# PLANNING DESIGN STUDIO

Location: 8419 Manchester Road, Brentwood, MO

Referenced Subject: Landscape Plan Review Initial Comments on:  
Site and Landscape Plans dated January 19, 2021.

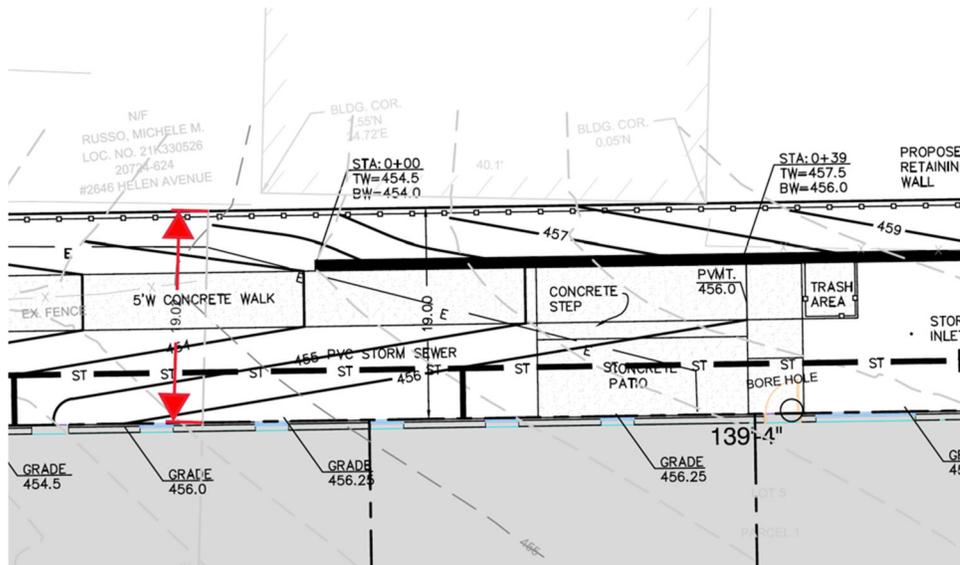
1. The design provides no ADA accessible entrance to the building from the adjacent sidewalks.
  - a. There are five stairs between the main entry walkway on the south side of the building and the sidewalk along Helen Avenue on the west side of the property. For ADA compliance, a ramp should be provided that meets ADA guidelines described

- b. The main entry walkway on the south side of the building has a slope of 7.14%. For ADA compliance, walkways must be considered ramps if their slope is greater than 5.0%. Ramps in compliance with ADA guidelines should have a 5' x 5' landing located every 30,' with no segment of the ramp exceeding a slope of 8.33% or having a rise greater than 30". Handrails are required for ramp segments greater than 72" in length or with a rise greater than 6". **ADA access will not be proved along this sidewalk per comment above.**
- c. The site plan should provide more detail about how the concrete vertical curb should be designed to become flush with the parking lot and the concrete walk at the ADA parking spaces near the building entrance. If a ramp is needed it should be shown in the site plan. **Asphalt in parking lot will be ramped up to provide flush transition.**

below. **Petitioner proposes to use walkway at rear of building for ADA access. City Building Official is still reviewing this proposal.**
